## FOR THE RECORD

Project: Village at Grand Traverse (VGT-Phase 1 SUP#2009-1P)  
Final Engineering  
Stormwater Collection and Treatment System

# **Technical Memo – Storm Water Review**

RE: Grand Traverse Town Center  
Final Engineering Storm Water Review

BASIN #1 DETAIL

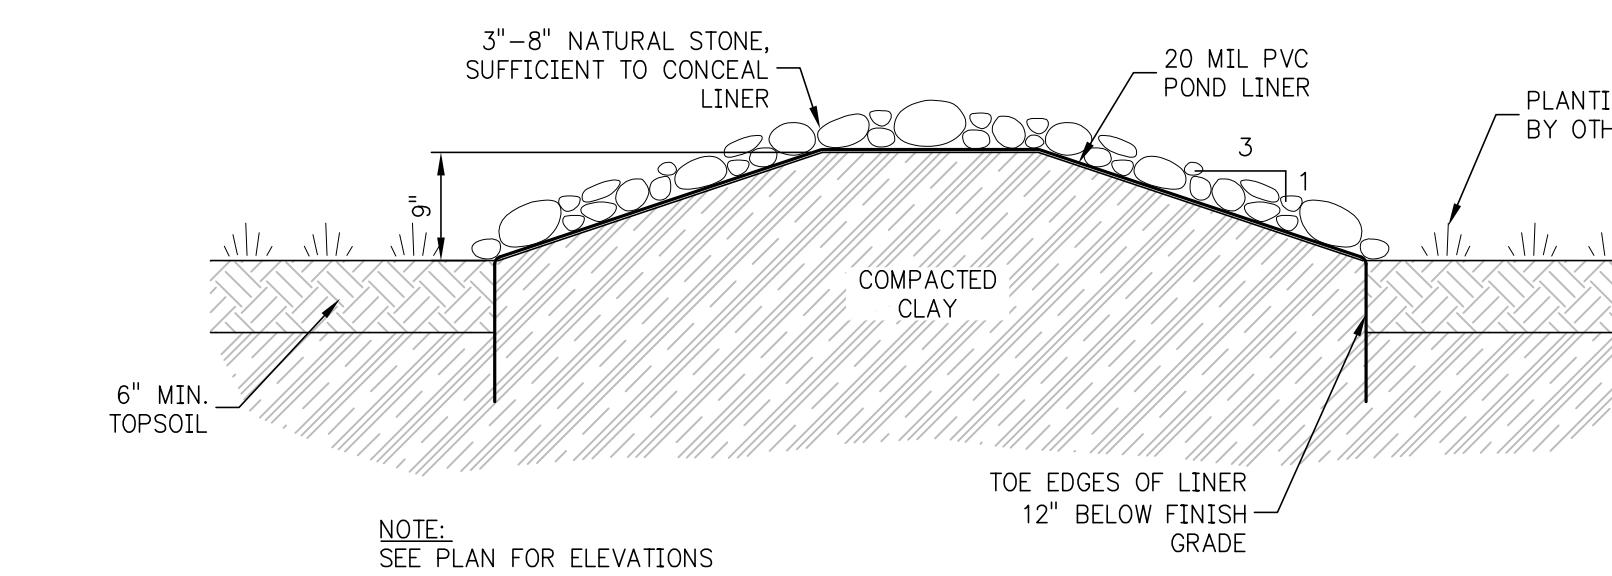
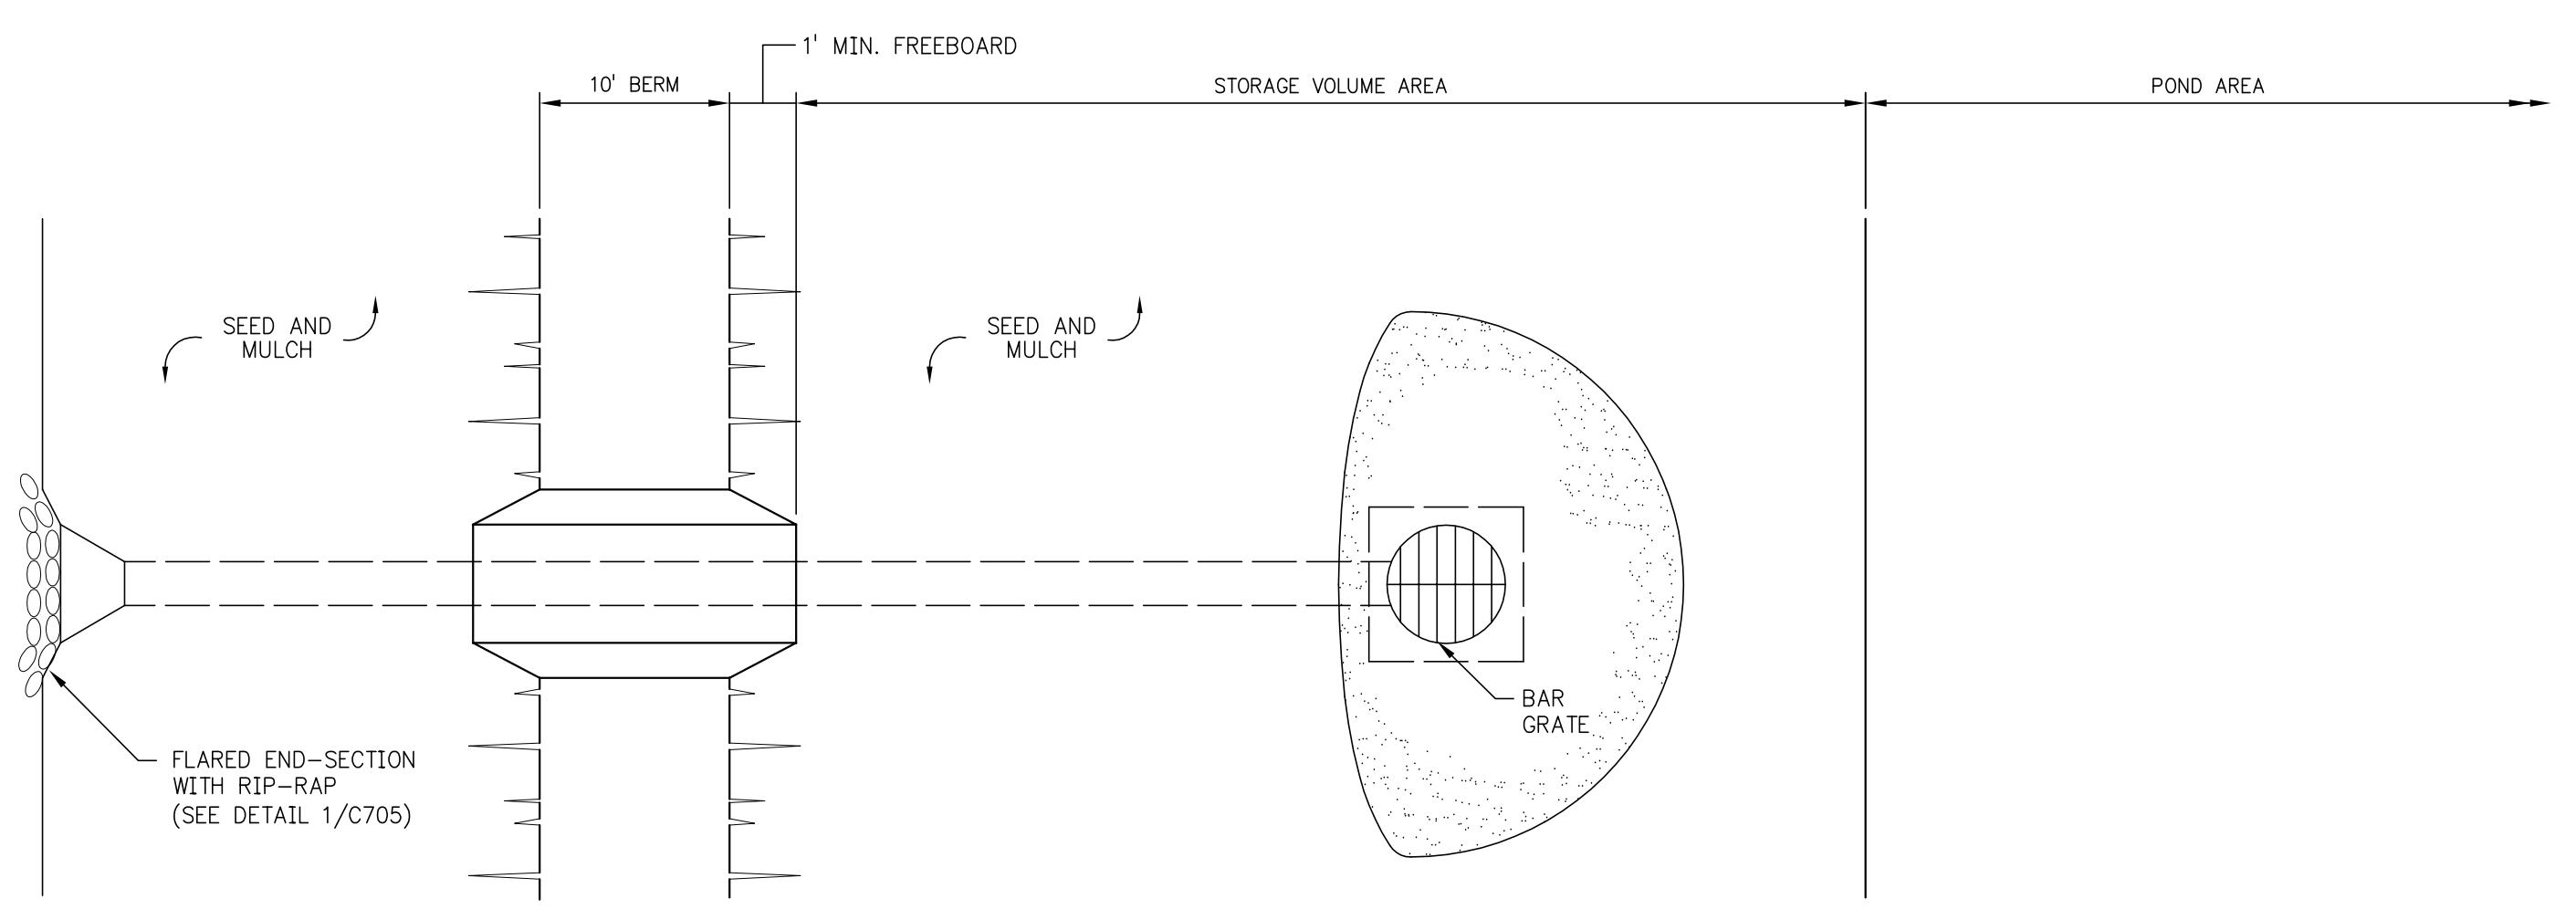
The latest drawings provided for review are plan sheets C312 “Basin #1 Detail” and C313 “Basin #2 Detail” revision no. 6 dated 05/05/2015. Engineering calculations for Watersheds #1 and #2 dated 05/05/2015 are also provided. An “Overall Grading Plan”, sheet C300 dated 09/05/2012 was previously provided.

Outlet risers are shown over five feet tall in both basins and 36 inches in diameter. Risers over five feet tall are required to be 48 inches in diameter per the Ordinance. The MDEQ Nonpoint Source Best Management Practices Manual BMP for a Wet Detention Basin describes guidelines for outlets. It is noted that outlets "should have an accessible, above-ground cap to allow easy cleaning" and outlets "should be designed so that trapped trash and debris can be easily removed". The outlets provided meet the criteria of this BMP and leaving the current outlets structures in place in this case is acceptable in our professional opinion.

**BASIN #2 SLOW RELEASE DETAIL**

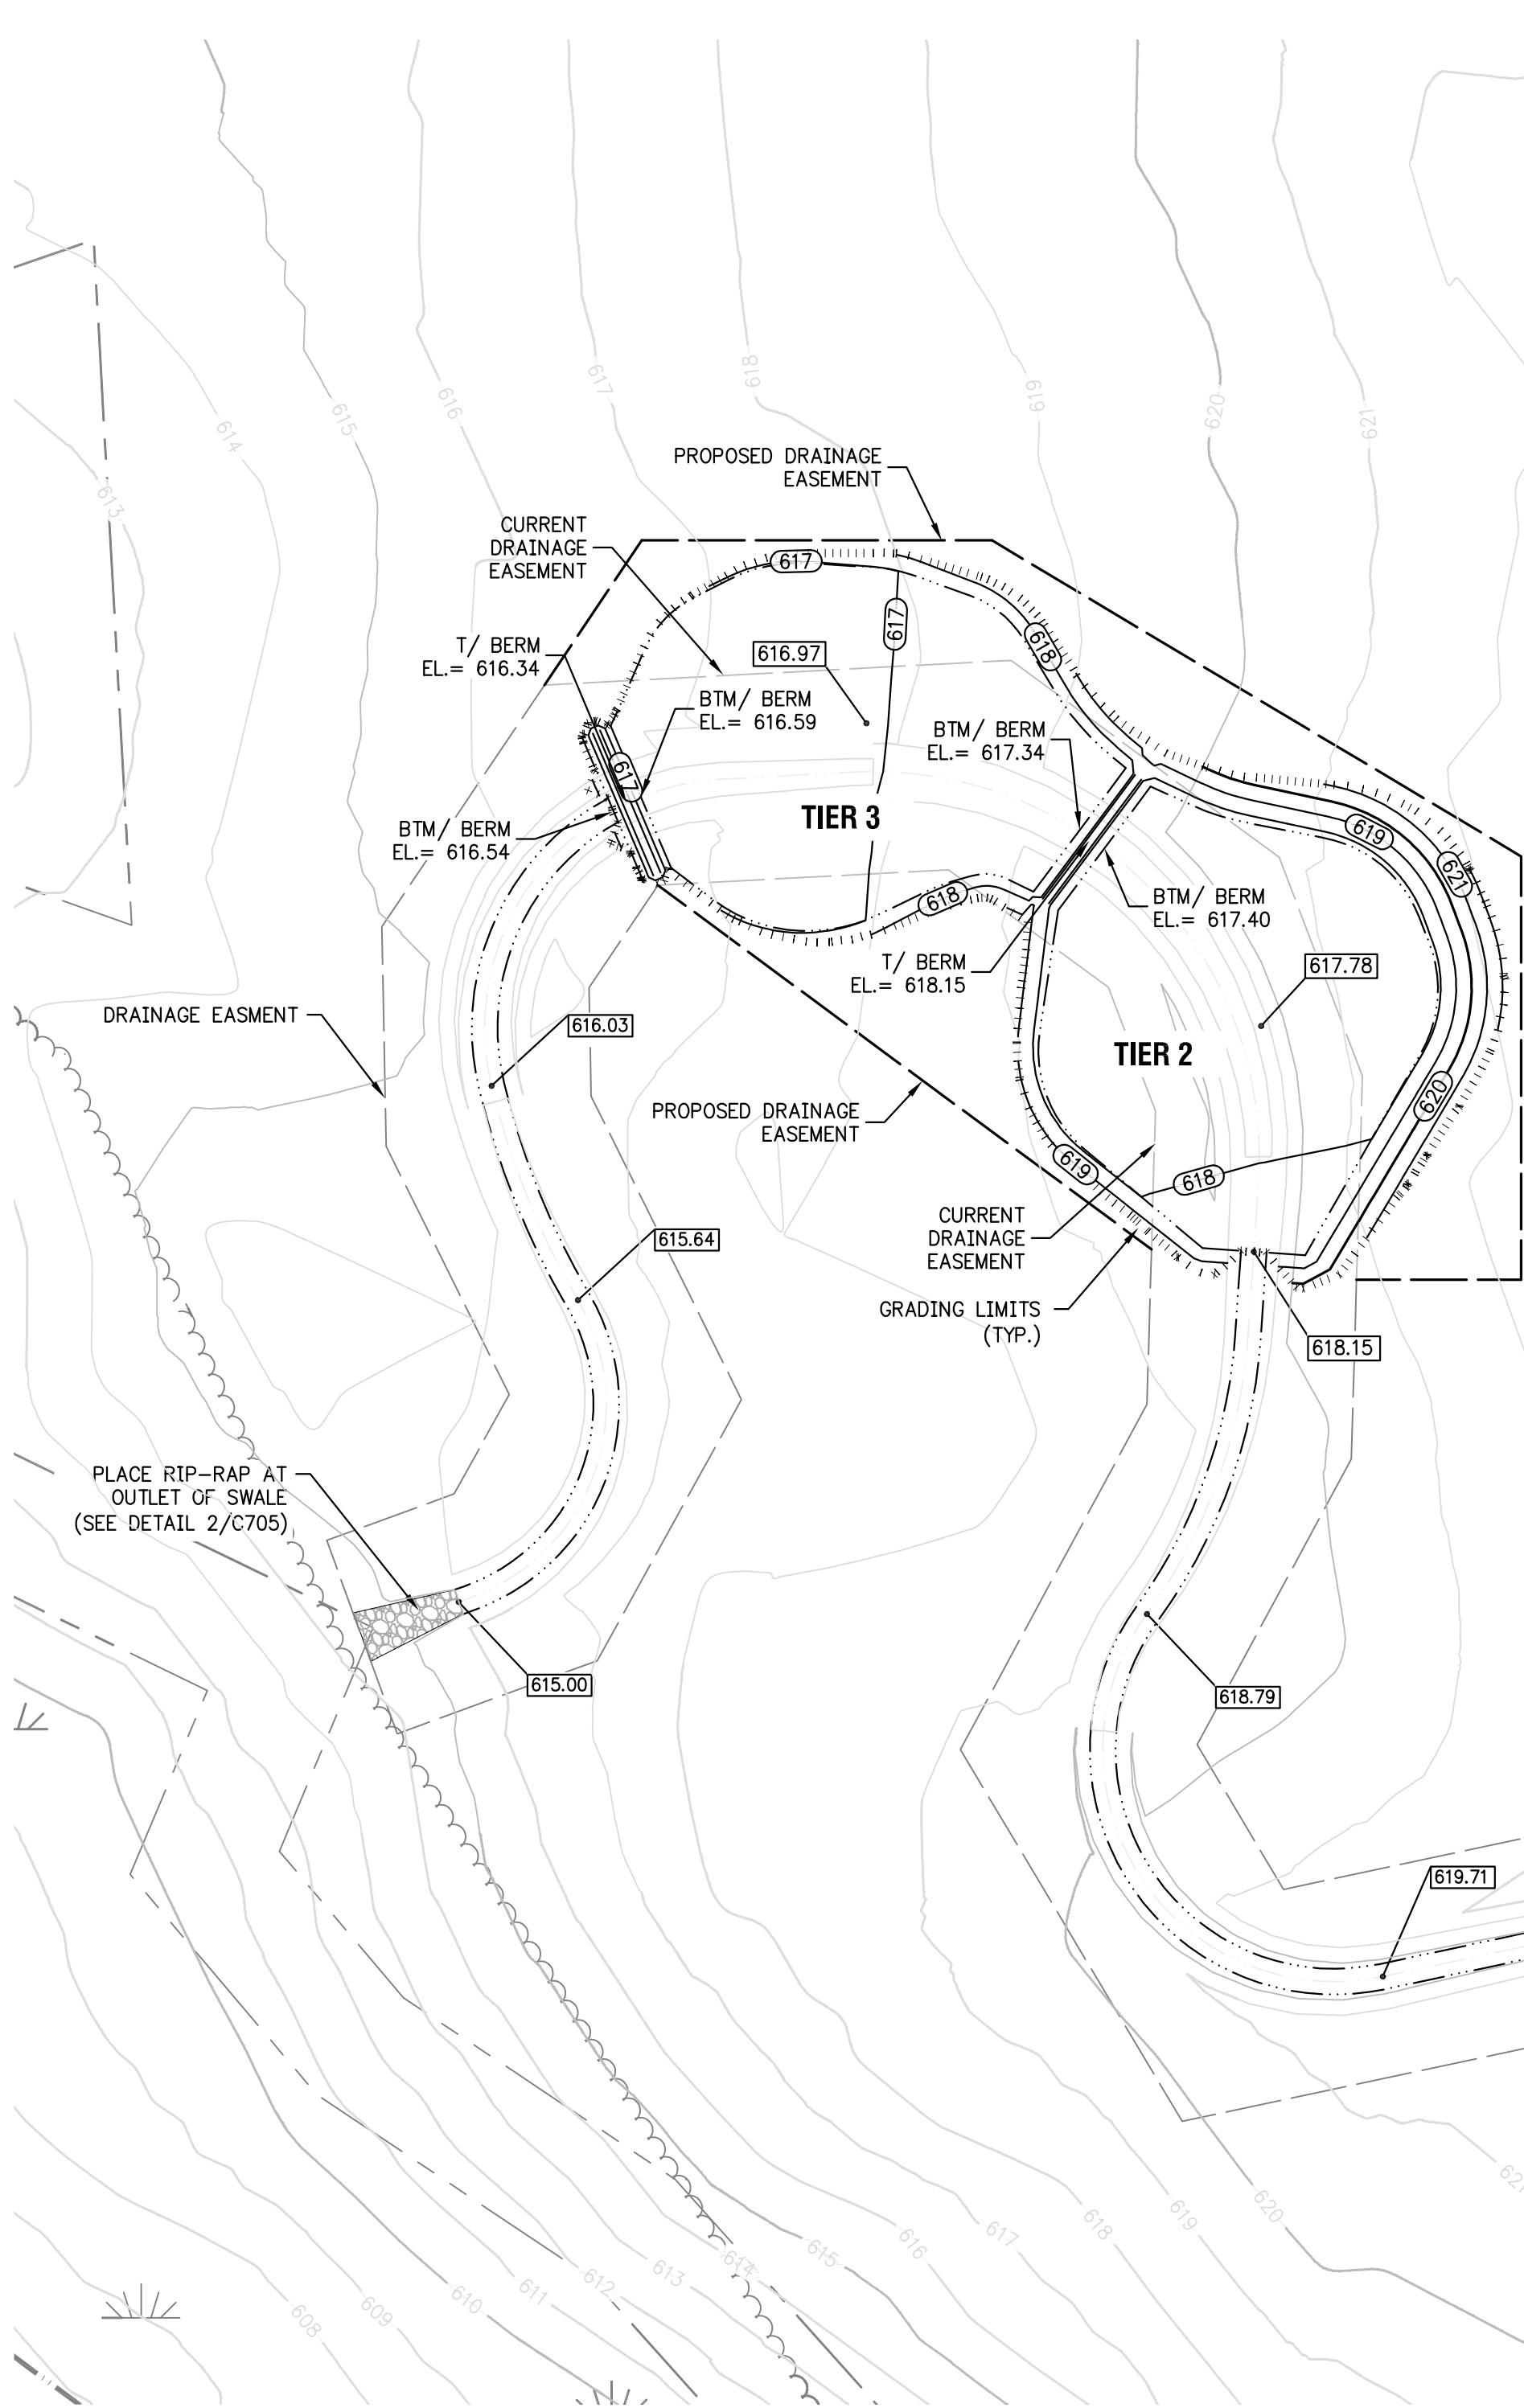
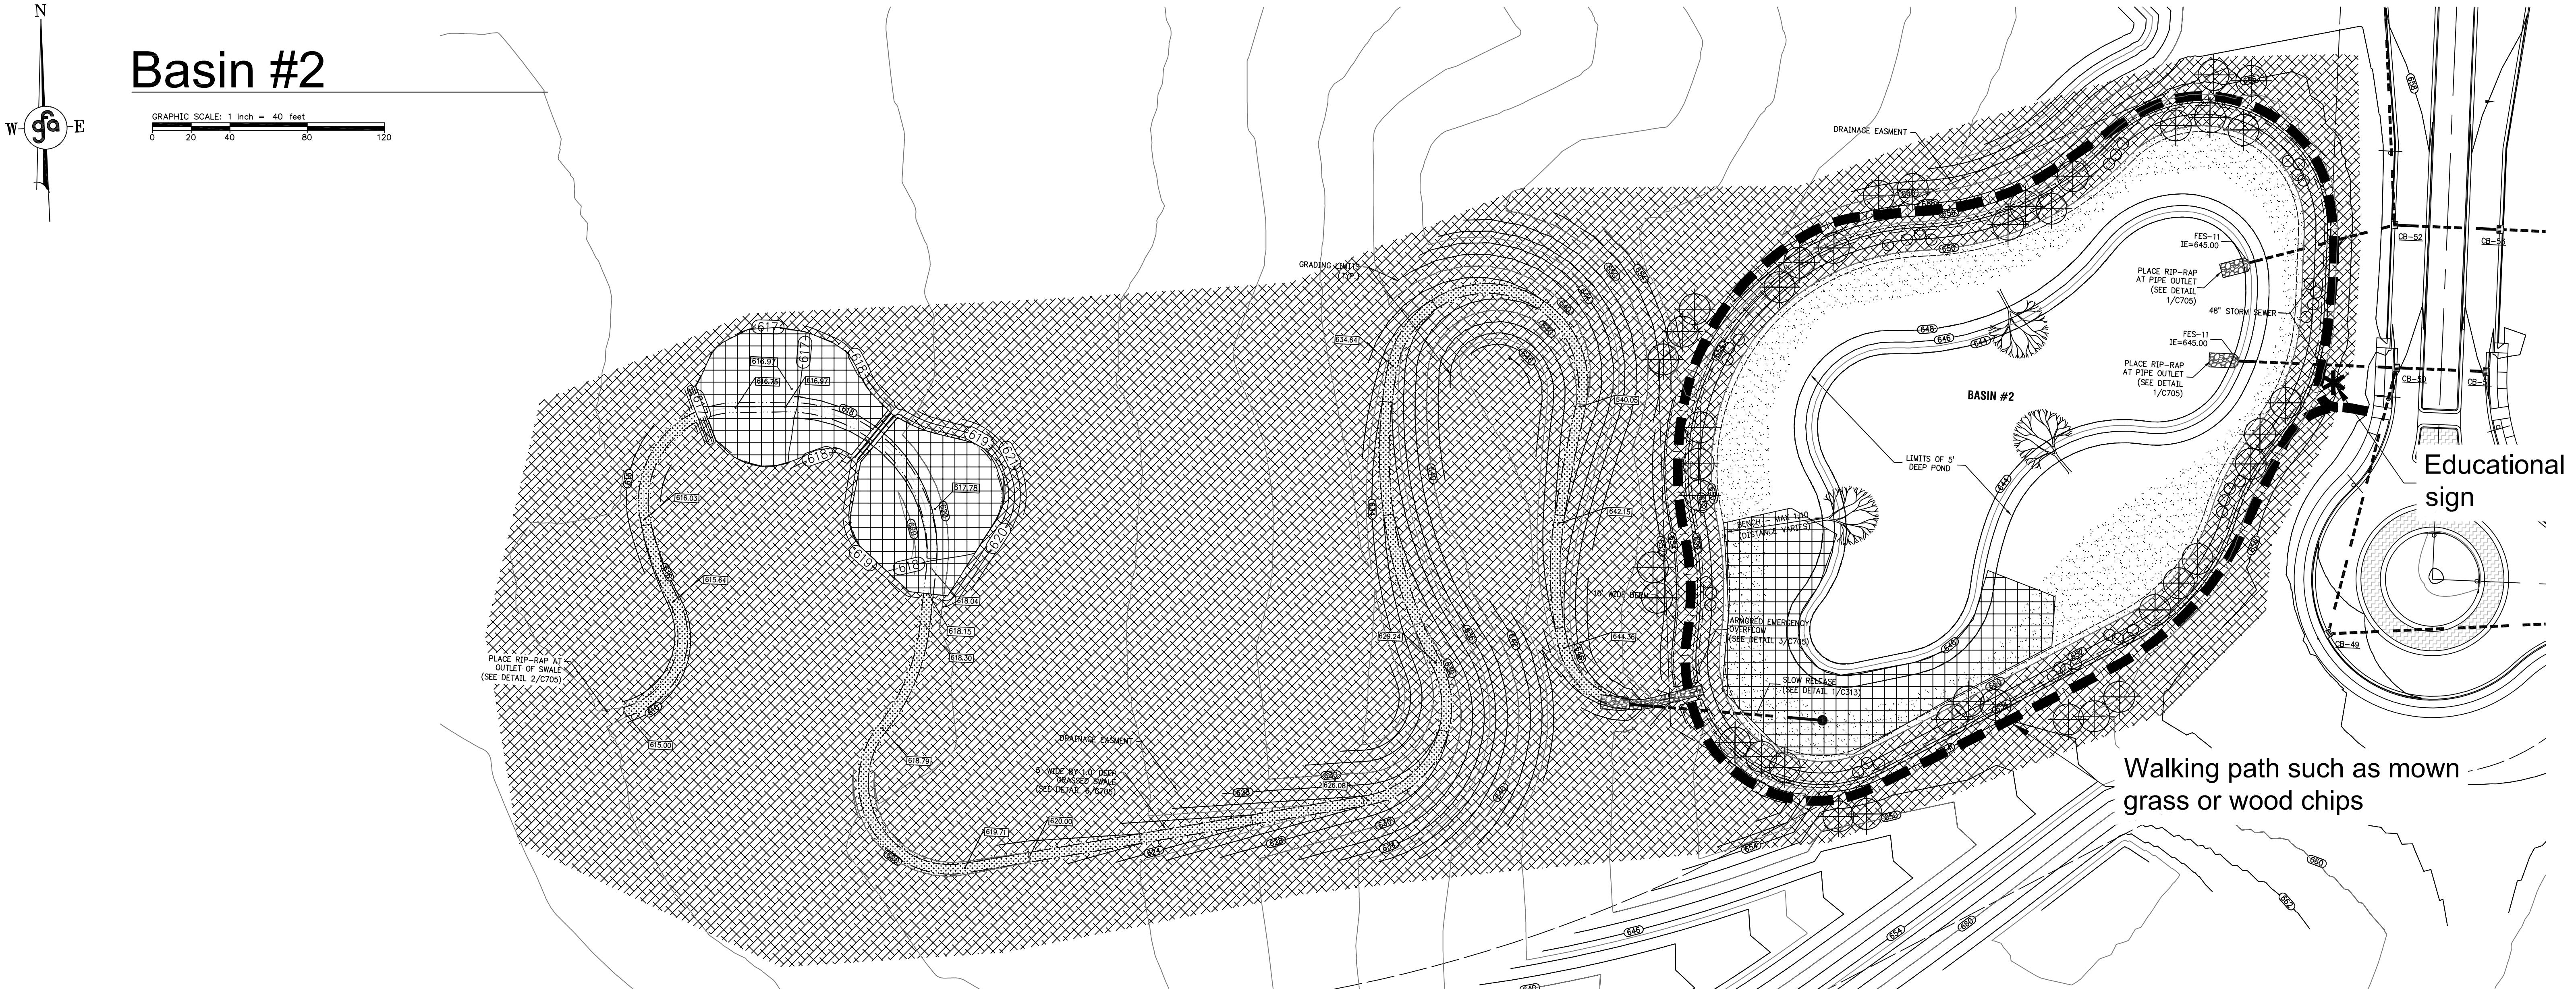
It is noted the inlet pipes at Basin #2 are shown below the permanent water level in that basin. It was noted by the design engineer that site constraints at this location necessitated placing these inlet pipe inverts below the permanent water level. Additional hydraulic calculations were provided showing that the pipes will function in this situation and flood volume water levels won't rise above the rim elevations of the drainage structures causing flooding or uncontrolled release of runoff.
